Agenda for 91st PCCM

Govt. of India
Ministry of Power
North Eastern Regional Power Committee
Shillong

91st Protection Coordination Sub-Committee Meeting

Date: 20/08/2026 (Thursday)

B.8 GD at North Lakhimpur area of Assam on 19th Jun'26:

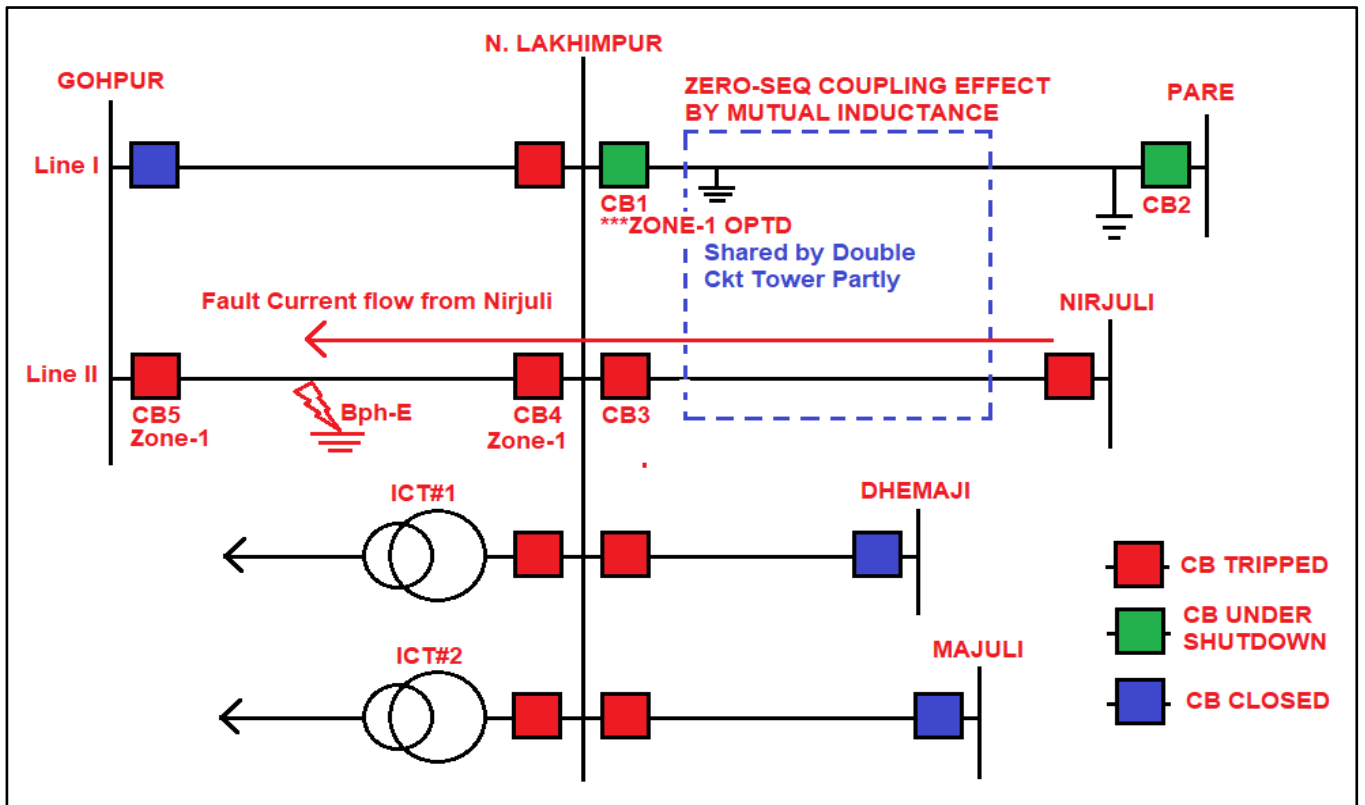
Protection issues observed: Zero-Sequence Mutual Coupling effect leading to LBB Operation

Remedial Measures: The LBB busbar trip delay will be increased from 100ms to 200ms. The “*Mutual Compensation CT wirings*” will be carried out between the Pare and Nirjuli Panels. The LBB protection will be kept OFF when lines are under shutdown and earthed at both ends (for double circuit lines) at N. Lakhimpur end. *(The Pare Panels are not under AEGCL Jurisdiction)*

Hence, AEGCL is requested to make necessary changes in coordination with the MUML (Pare line bay owner at N Lakhimpur).

B.9 GD at Along area of Arunachal Pradesh 9th July’26:

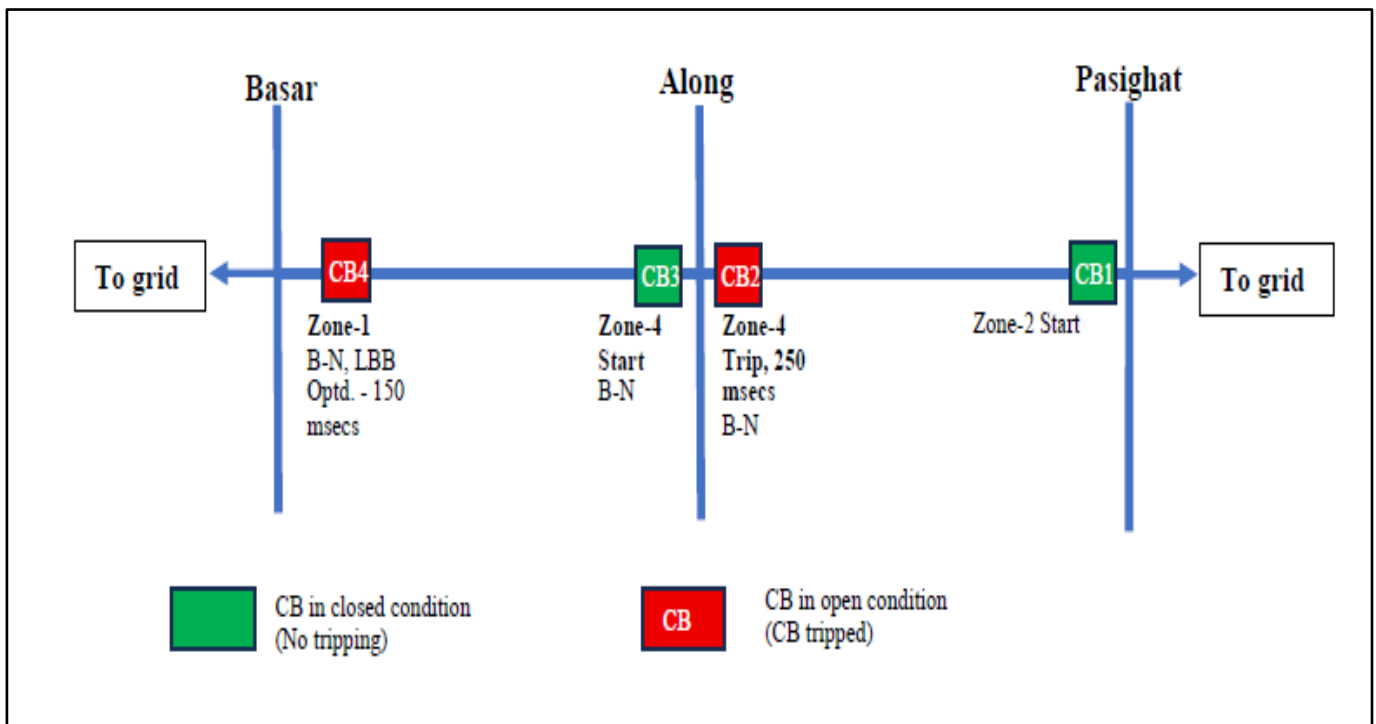
Protection issues observed:

- Zone-1 operation at the Basar end for a fault on the 132 kV bus at Along Substation appears to be unwanted and requires investigation.
- At the Basar end, the B-phase pole opened within 80 ms following Zone-1 operation. However, the fault continued to be fed towards Along through the B-phase, resulting in LBB operation within 150 ms, followed by three-pole tripping. The reason for the failure of fault clearance following single-pole opening requires detailed investigation and appropriate corrective measures.
- The similar CB opening issue at Basar end of 132 kV Along – Basar line also observed at 09:30 Hrs of 4th August 2026.

Hence, DoP, Arunachal is requested to take corrective action at the earliest.

B.11 GD Tuirial HEP of NEEPCO due to frequent tripping of the 132 kV Kolasib – Tuirial line' July26:

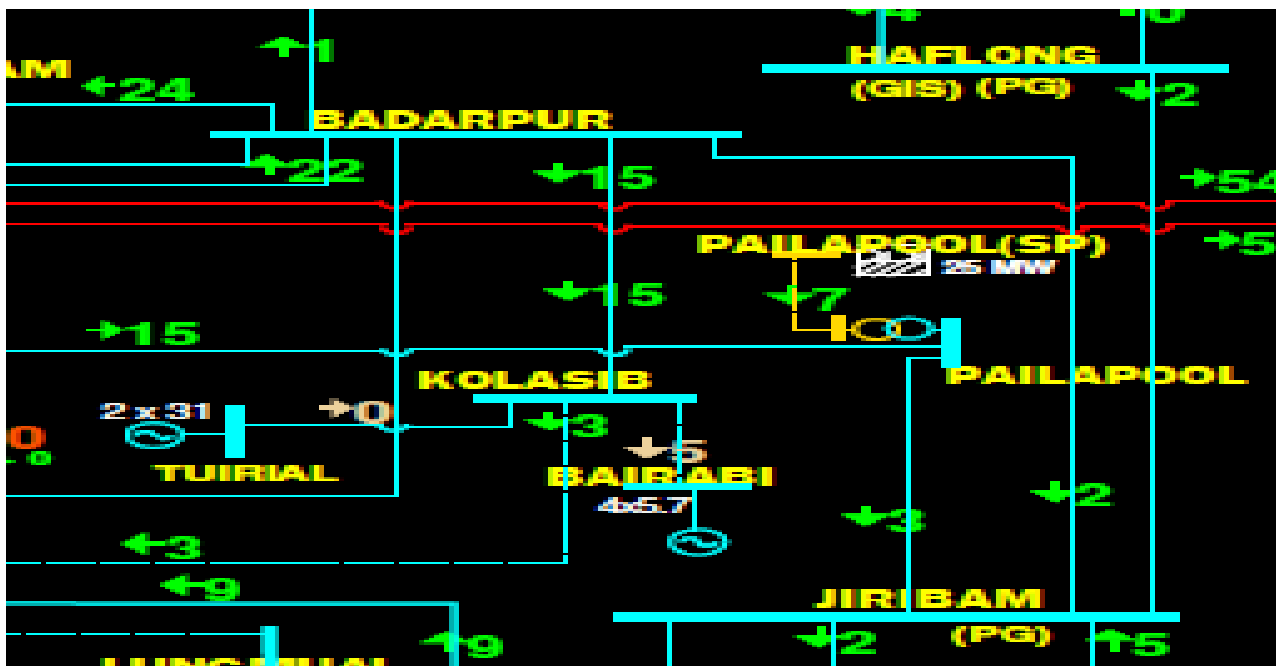
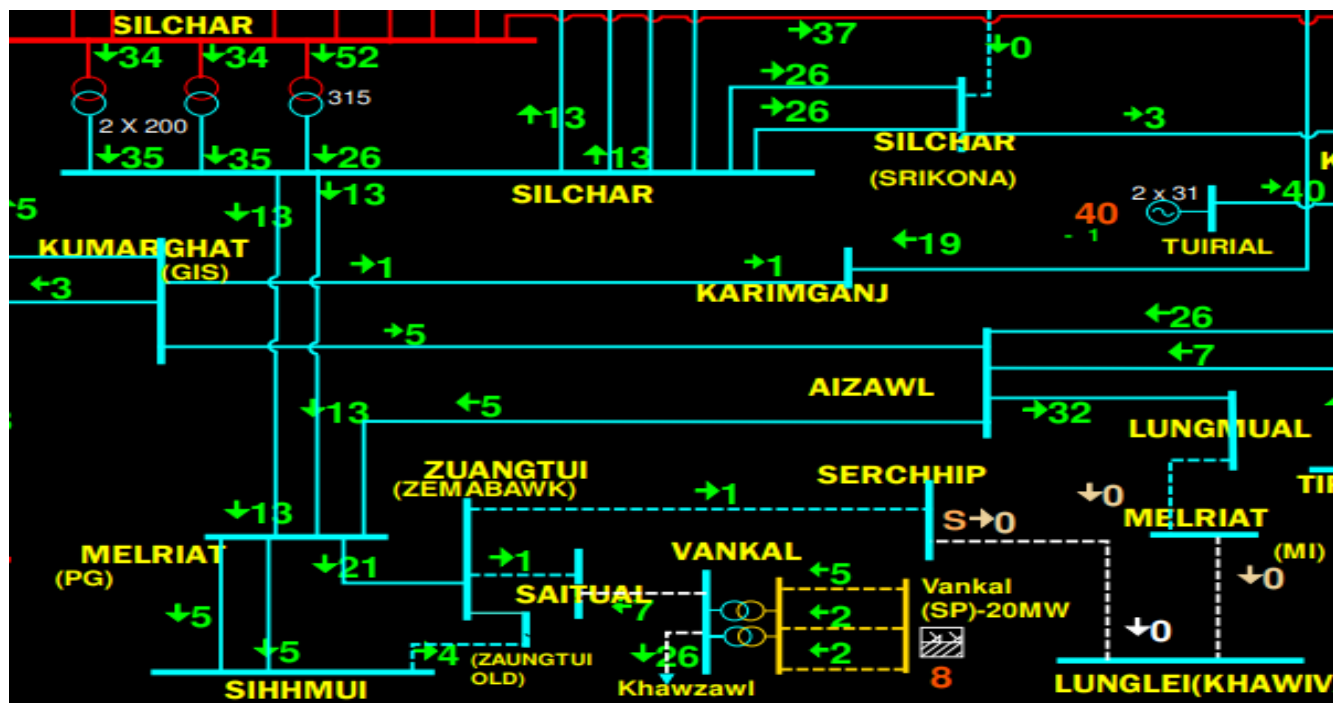
This indicates a huge number of tripping occurred only at Tuirial end during fault beyond the line caused by the Highset EF protection enabled with Time delay of only 50 msecs only.

1. Regular line maintenance to avoid outage of Tuirial generating plant.
2. Replace the backup relay at Kolasib for Tuirial line for which DR extraction is not possible. Hence, impacting the proper fault analysis.

1. Disable the Highset EF protection at Tuirial end in line with the NER Protection Philosophy.

B.13 Protection Issues at the Ningthoukhong SS on 27th Jun'26:

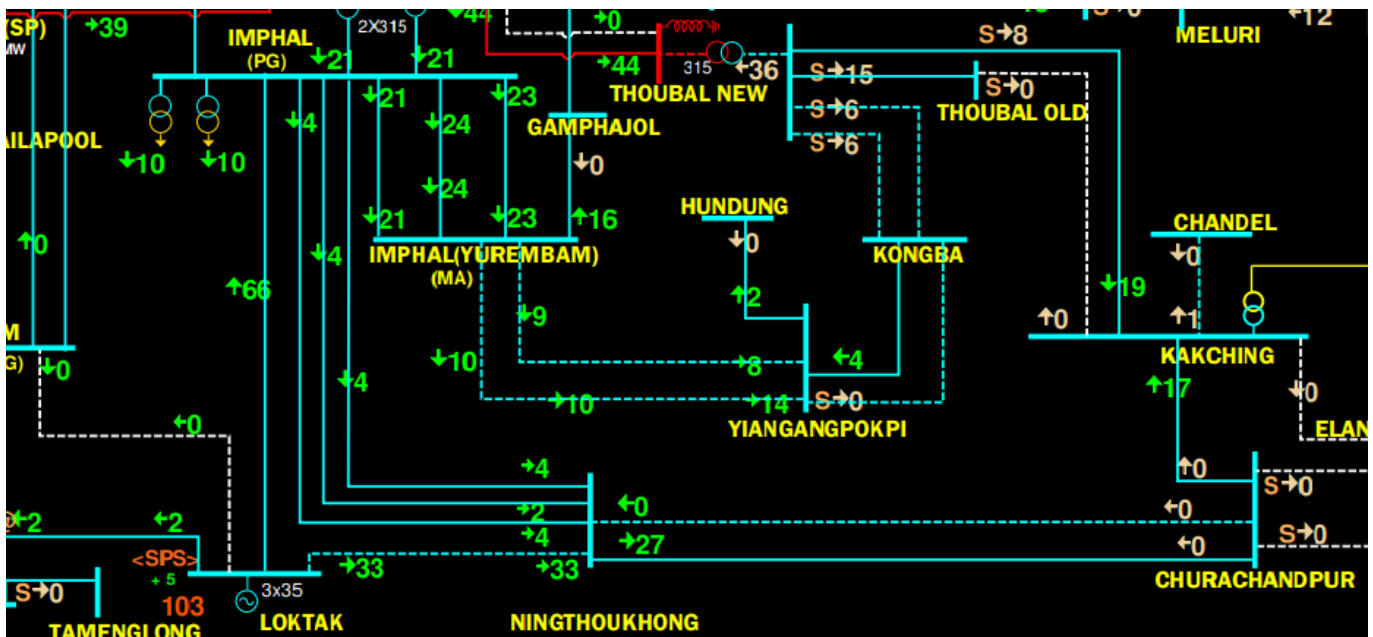
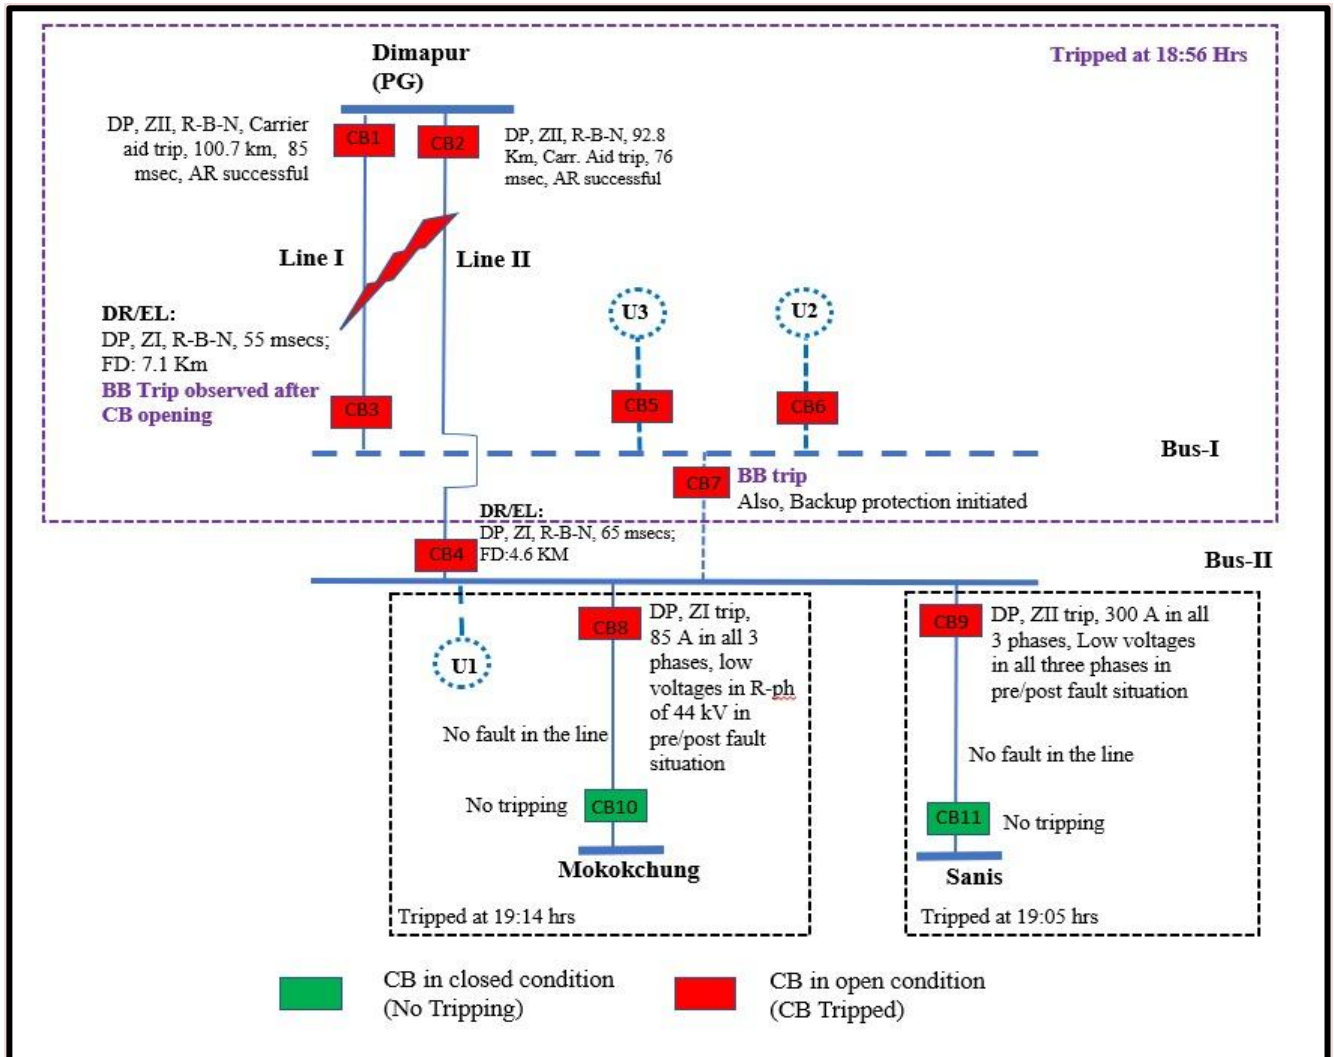
The fruitful analysis could not be performed due to the non-submission of the DR at Ningthoukhong end.

Hence, MSPCL is requested to share the root cause of the tripping.

B.15 GD at P K Bari area of Tripura 17th July 2026:

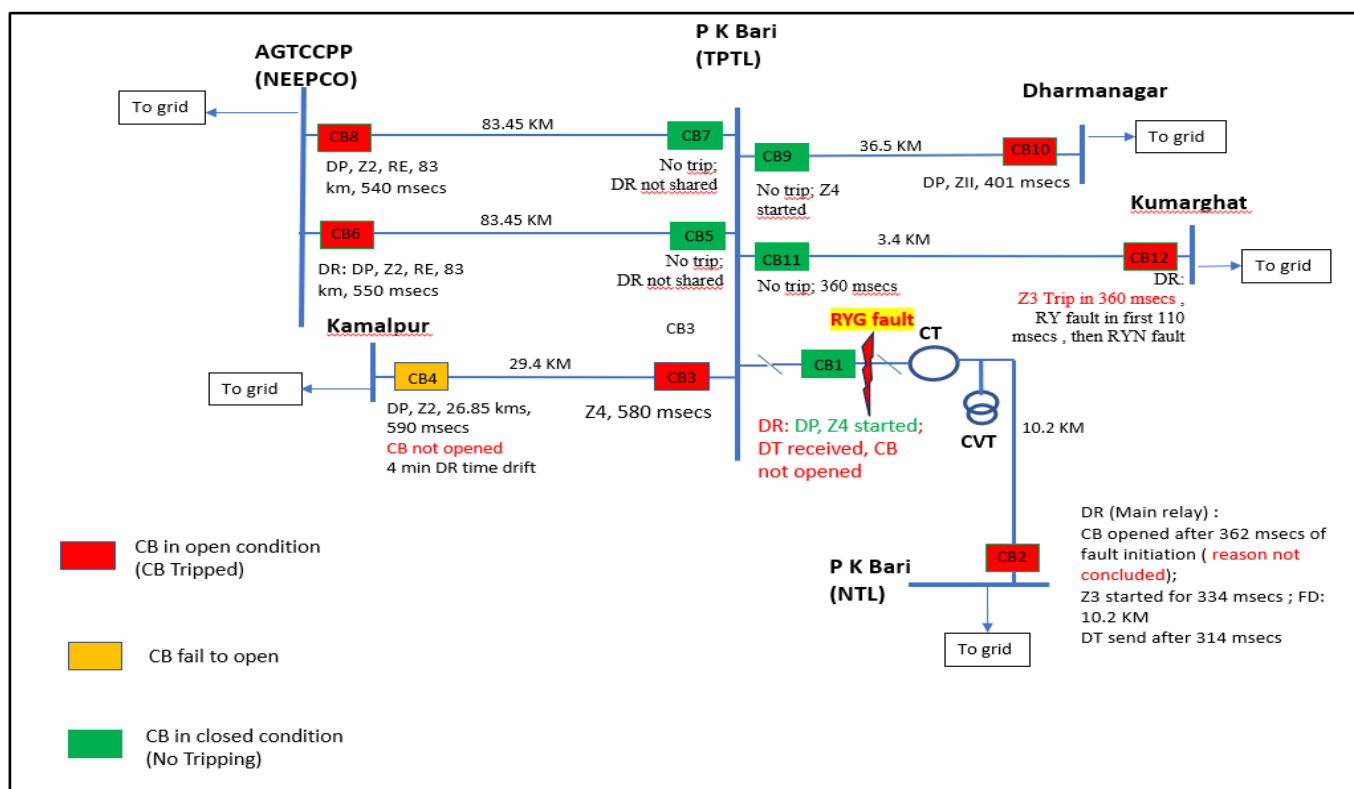
- R-Phase Al tube link between 132kV CB and Line Isolator of 132kV P.K.Bari(ISTS)-P.K.Bari(TPTL) Line at P.K.Bari(TPTL) end got disconnected from CB as the connecting pad cracked open and resulted flashover.
- It was also observed that the “cct fail Z1” alarm is in raised condition for Bus-Bar Relay, which resulted non-operation of Bus-bar differential relay to isolate this fault

1. **P K Bari (TPTL):** Non-operation of the Bus Bar protection at P K Bari (TPTL) & reason for tripping on DT received is not confirmed.
2. **P K Bari(NTL):** Initiation of ZIII observed. However, ZII not initiated; Unwanted DT sent from NTL end.
3. **Kamalpur:** CB not opened after issuing ZII trip command by the DPR needs to be reviewed.
4. **Kumarghat:** ZIII tripping in 361 msec needs to be reviewed;
5. DR standardization required at CB11.
6. Time drift observed for CB1 (10 min), CB3 (1 min), CB4 (4 min), CB9 (2 min), CB10 (5 min).

C.1 GD at Doyang Power Station of NEEPCO and Sanis area of Nagaland on 1st July'26:

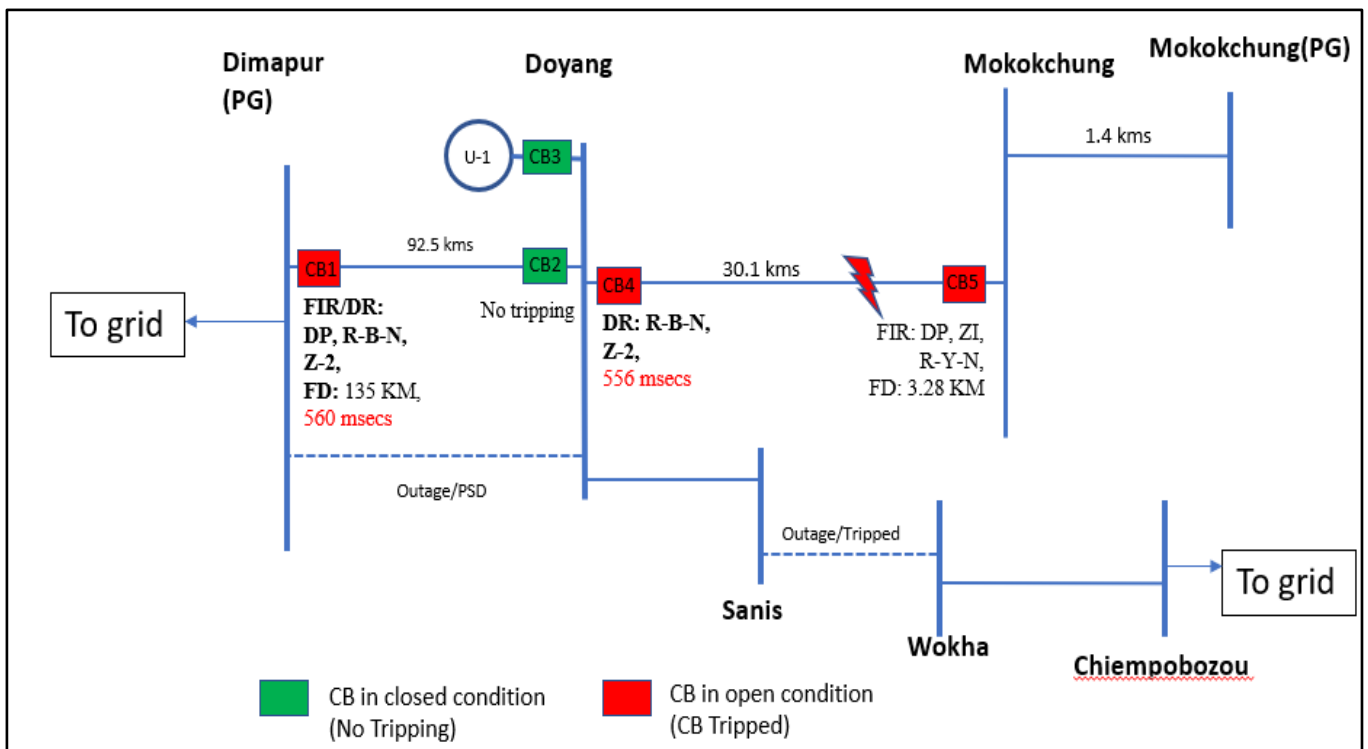
The 500 msecs time delay for ZII is in line with the NERPC protection philosophy for ZII time delay.

Reviewing of the ZII time is required as there is no DTPC & PLCC does not supports Tele-protection, hence carrier aided protection was not operated at Doyang end of 132 kV Mokokchung line.

In the pre-PCC GD discussion meeting held on 14.08.2026, NERPC suggested to change Z2 delay at Doyang for Mokokchung line to 400 msec and at Dimapur (PG) to 600 msec for Doyang line.

C.5 Grid Disturbance in Mendipathar area of Meghalaya Power System on 4th June'2026:

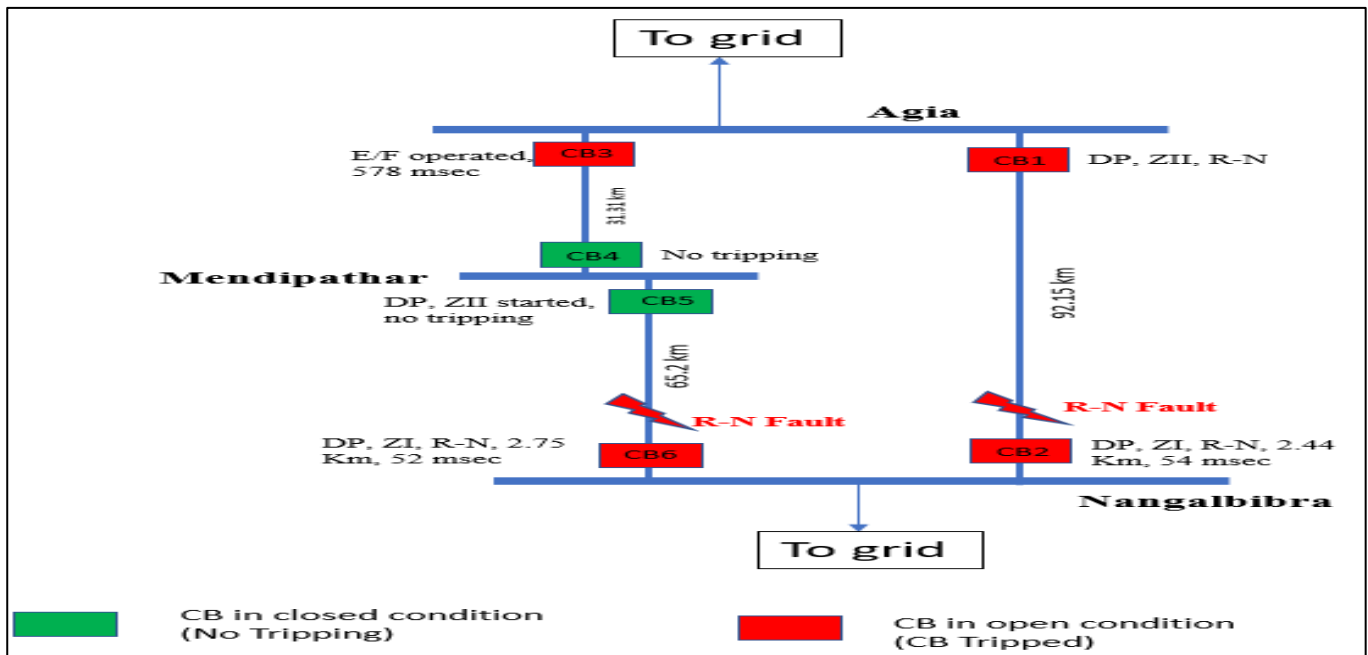
Root cause: Tripping occurred due to multiple lightning faults near Nangalbibra.

- Relay at Mendipathar for Nangalbibra line to be tested.
- MePTCL to provide the ZII settings and EF settings, as mentioned above, to NERPC and NERLDC at the earliest.

C.6 Grid disturbance in Pasighat area of Arunachal Pradesh on 3rd June'2026:

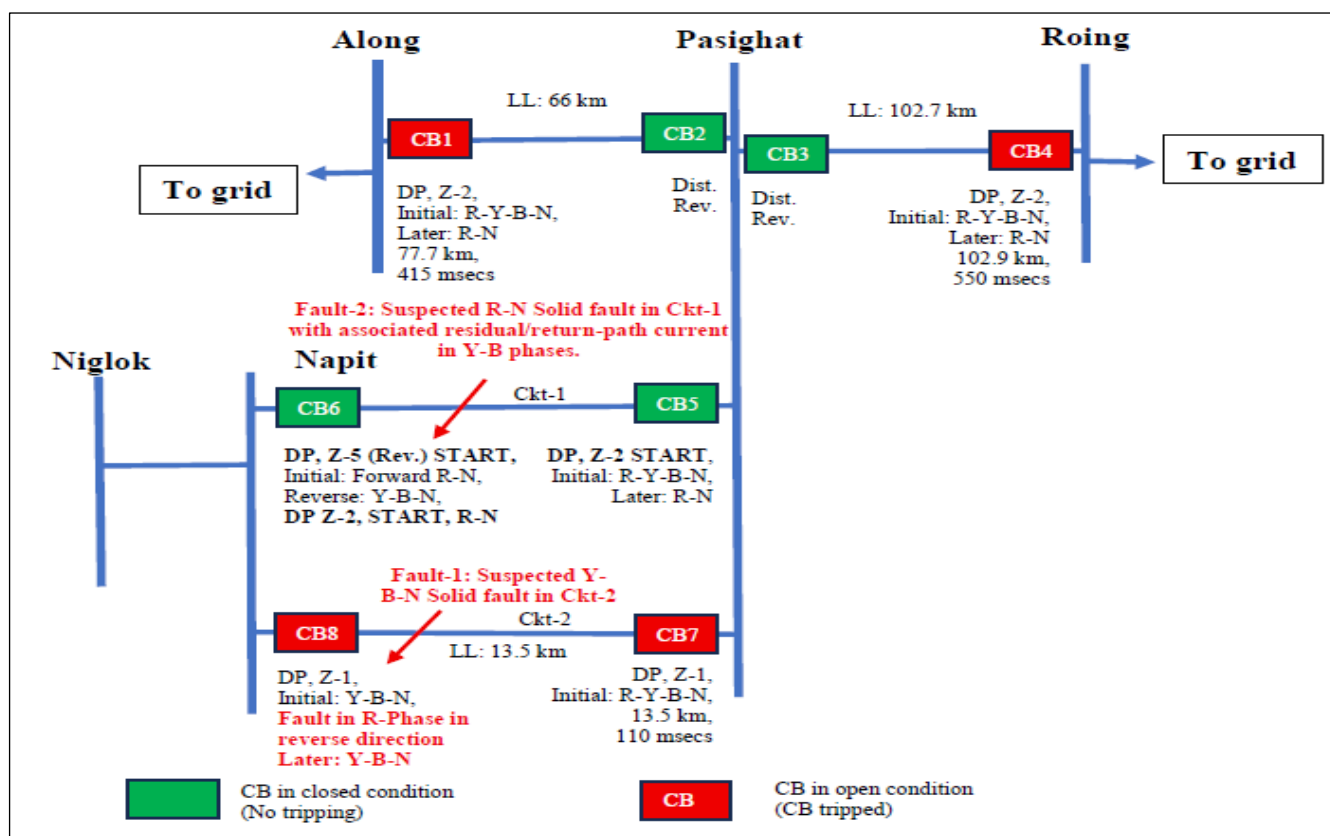
A three-phase-to-ground fault (R-Y-B-N) appears to have occurred in the system connected at Pasighat. The fault initially persisted as a multi-phase fault for approximately 170 msecs, after which it evolved into a predominantly R-phase-to-ground fault.
